Objection submission COM/2019/81 -

Nucrush Traffic Impact assessment (SCR Pavement Impact) is incorrect

FIGURE 2.4 – SURVEYED PEAK HOUR TRAFFIC VOLUMES AT THE TAMBORINE – OXFENFORD ROAD / MAUDSLAND ROAD INTERSECTION

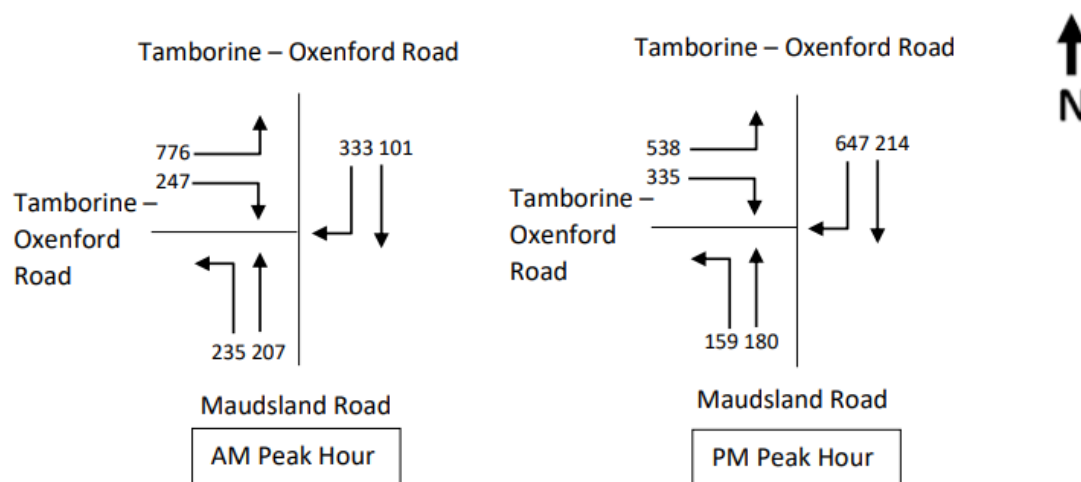
Section 2.3 Current Traffic Volumes, Fig 2.4 states it is "Surveyed Peak Hour Traffic Volumes at the Tamborine - Oxenford Road /Maudsland Road Intersection" (Attachment B1). But, there appears, however, to be absolutely no traffic survey information submitted for this Intersection. A cursory glance at the Figure 2.4, "AM Peak Hour" figure suggests 348 (247+101) vehicles approached the Nucrush site intersection via Maudsland Road, heading south, from the Tamborine - Oxenford Road (Attachment B1). However, in the Surveyed Traffic Volumes Appendix B (Attachment B3) shows that 395 vehicles made this journey. Thus, it would appear the Figure 2.4 results do not originate from the December 2014 highly inadequate two hour traffic survey. So where do the "Figure 2.4 - Surveyed Peak Hour Traffic Volumes at the Tamborine - Oxenford Road / Maudsland Road Intersection" originate? It certainly would not seem to have been submitted as part of the Traffic Impact assessment, as inferred.

Attachment B3- Appendix B - Surveyed Traffic Volumes at Site Access Intersection

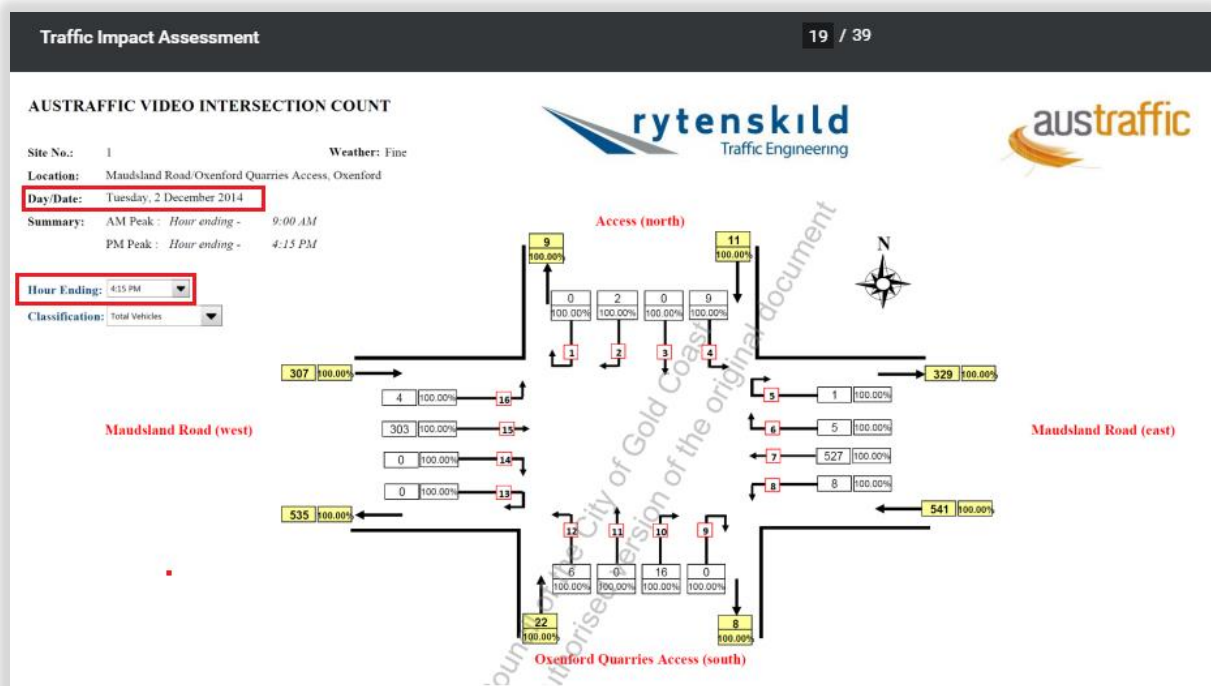
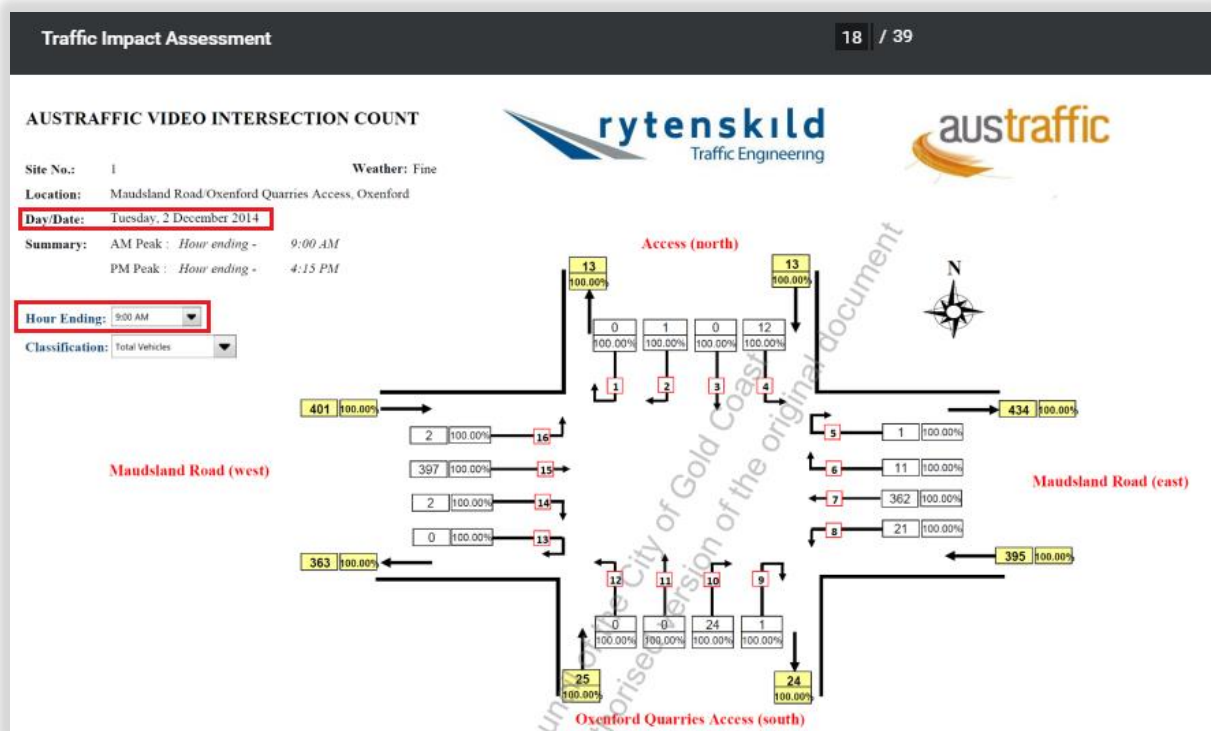
In the Traffic Impact assessment (SCR Pavement Impact Assessment), Dated 28th November 2019, Version 1, it is claimed that "The full traffic survey is provided in Appendix C" (reproduced in attachment B1). However, Appendix C is just a record of loaded trucks exiting the site (Attachment B2). There is an extremely limited Traffic survey provided in Appendix B. However, this is not a "full traffic survey" it is merely two one hour snapshots taken in the morning and afternoon on a seemingly arbitrary day way back in December in 2014 (Attachment B3). Hardly "The full traffic survey" the Traffic Impact assessment infers and I beleive needs.
